RE: Brechfa Forest West Wind Farm – Infrastructure Planning Commission Consultation Exercise (Section 42, Planning Act 2008)

The attached report represents Carmarthenshire County Council's response to the consultation and provides assessment, commentary and review of the draft Environmental Statement. The report was endorsed by members of the Council's Planning Committee on 31st March 2011.

Figure 1 – Noise Contours and receptor locations affected by the consented Alltwalis, and the proposed Brechfa Forest West and Bryn Llywelyn wind farms.

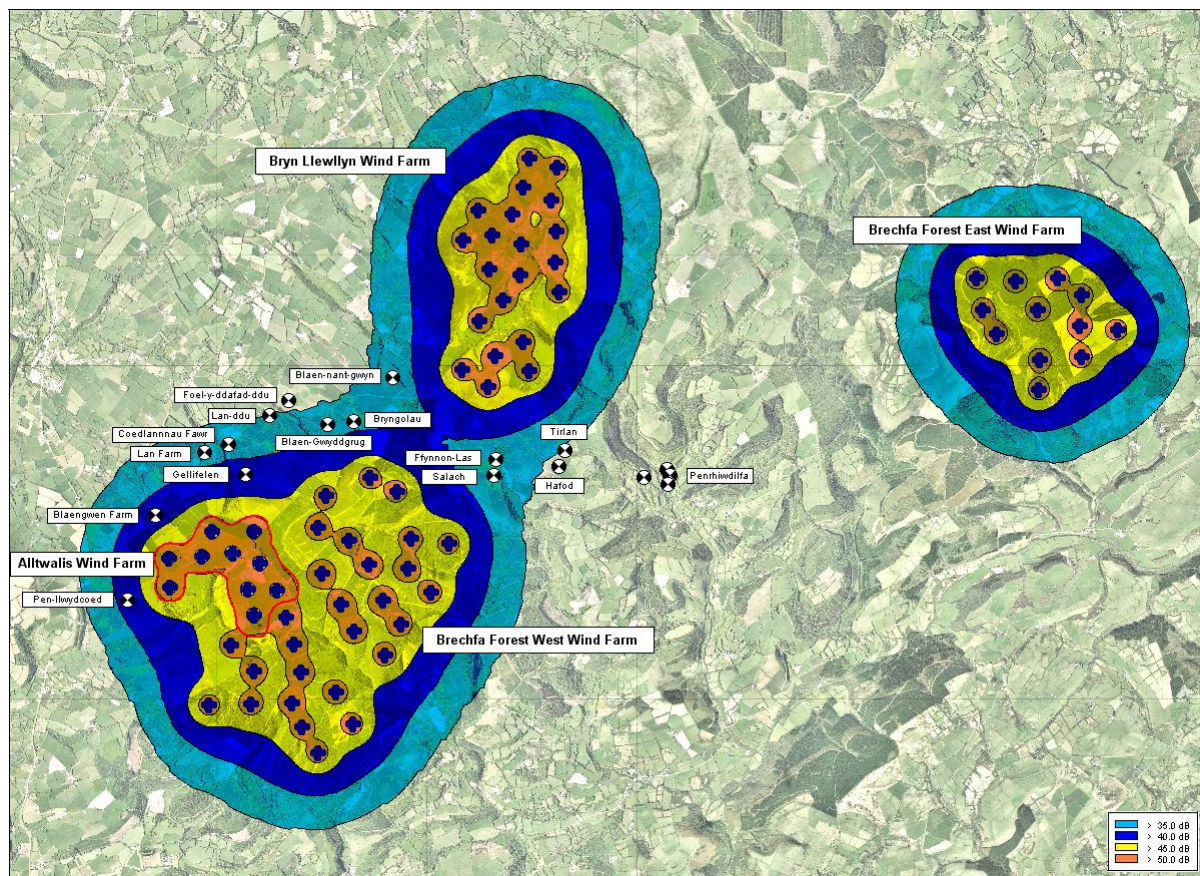
The applicant has not shown graphically how the noise from each respective wind farm would influence noise levels at the surrounding receptors, but the following Figure 1 shows the area affected by the existing Alltwalis wind farm, the proposed Brechfa Forest West wind farm, and the southern edge of the proposed Bryn Llywelyn wind farm.

It can be seen from Figure 1 that there are a number of properties that lie approximately north east of the existing Alltwalis and proposed Brechfa Forest West wind farms, and approximately south of the proposed Bryn Llywelyn wind farm. It is therefore likely that these properties would be exposed to wind turbine noise for a greater proportion of time than they would from the Brechfa Forest West wind farm alone.
